Interested Party number 20025524. Nick Scarr. Deadline D6

This document is a response to the ExQ1 Part 3 of 6 (*The Examining Authority’s written questions and requests for information (ExQ1) ExQ1 PART 3 OF 6 REP5-129*) and refers to my submitted documents, [REP3-119 \(REP2-393\)](#) and [REP5-253](#).

Professorial review of paper: Sizewell C – Coastal morphology, climate change and the effectiveness of EDF’s Flood Risk and Shoreline Change assessments. May 2021

Three major 100-year episodes of erosion, accretion and relative stability of the Sizewell shoreline discussed earlier on a large-scale air photograph:

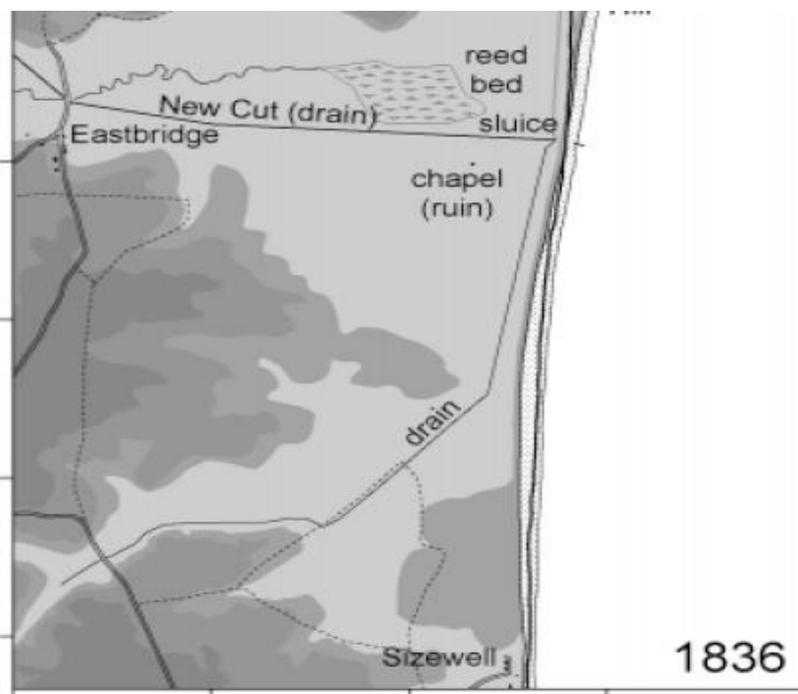
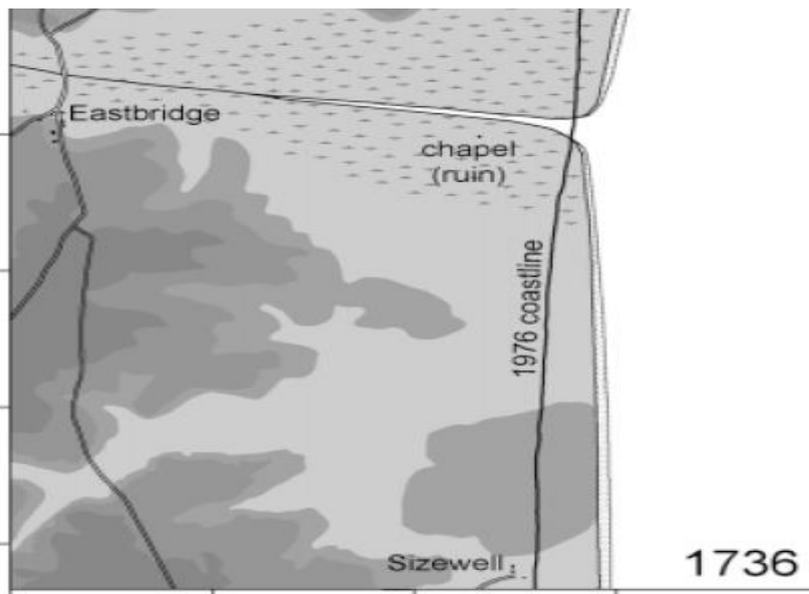
1. Orange arrow shows erosion period 1736-1836.
2. Light blue arrow shows accretion period post the development of the Sizewell-Dunwich banks, 1836-1920.
3. Light green double arrow shows the relative stability period 1920- present.

EDF/Cefas, in its consideration of the impacts on coastal processes appear to overlook the much of the detail of these events briefly commenting on only two distinct phases:

Plate 5.3: Representation of the main platform and HCDF in the inundation model

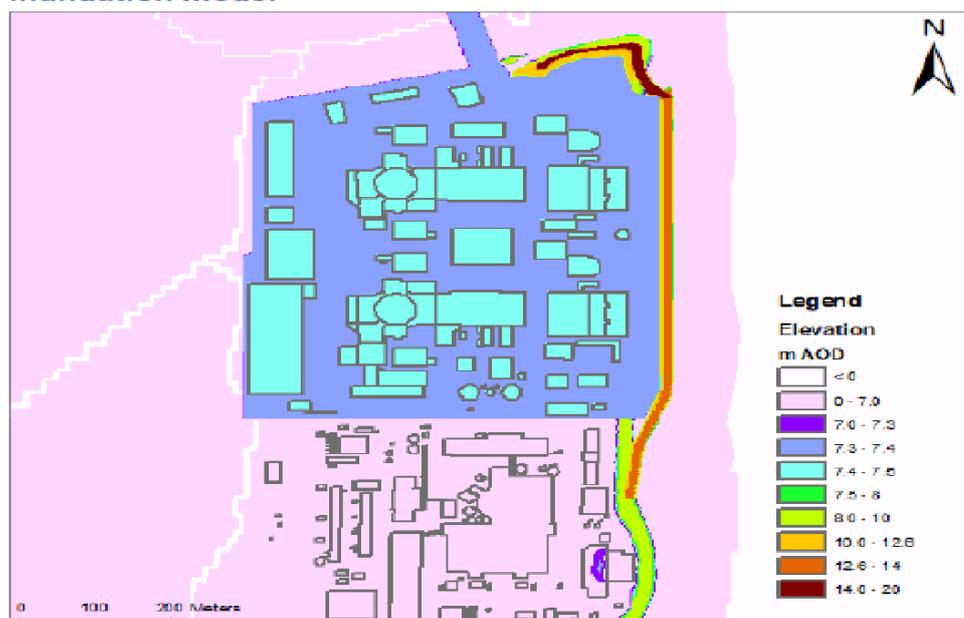
- However, the adjoining Sizewell B which has a 10m AOD sea defence crest height. The proposed sea defence designed for Sizewell C (14.6m - 16.4m AOD) does not appear to cover the frontage of Sizewell B (see Plate 5.3 below). **I have not seen an explanation for this. Sizewell B will not respond to correspondence asking whether they will increase sea defence height. In its present form, according to EDF in its statement above, Sizewell B’s defences must represent a danger to itself and Sizewell C by 2046.**

EDF Addendum: Main Development Site Flood Risk Assessment Addendum Appendices A-F Part 10 of 10. Note in Plate 5.3 that the 12.6m-14.6m sea defence contour of Sizewell C merges into the mainly unchanged 8-10m Sizewell B defences

Plate 4.3: Proposed Permanent HCDF cross-sectional profile (extract from EDF Energy drawing no. SZC-EW0601-XX-000-DRW-400025 rev. 01, 27/11/20)

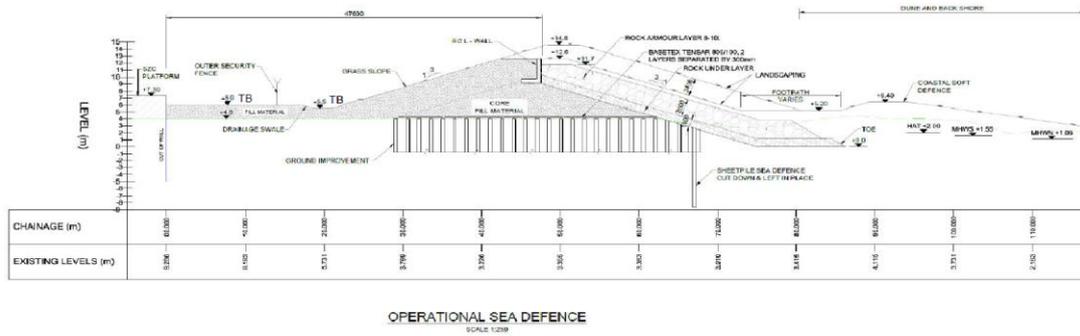
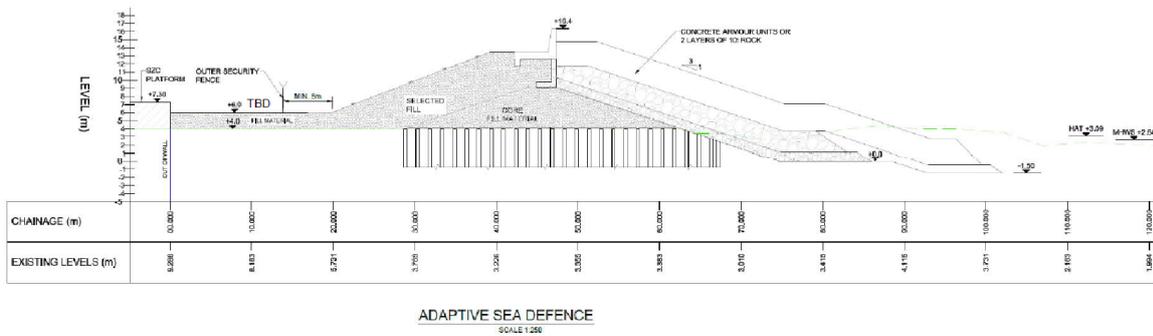
- 1 EDF’s image quality is poor but a swale is shown on the lower crest height. There appears to be a flat area which may offer flood storage capacity.
- 2 There is no indication of a concrete and steel wall topped with barbed wire for security from trespass.
- 3 Sizewell C defence crest height is much greater at **14.6m** AOD with adaptive change to **16.4m** AOD (with landscaping to **18m** AOD).
- 4 The Sizewell C finished site will be 35 hectares. See MDS FRA Addendum Part 10 of 10, op. cit., 2.3.4. (The building site will be 371.7 hectares)
- 5 Sizewell C will be built approximately 40m further to seaward than Sizewell B according to the East Suffolk Councils. East Suffolk Council, Extraordinary Meeting, Thursday 3 September 2020 at 6.30pm. Page 68.
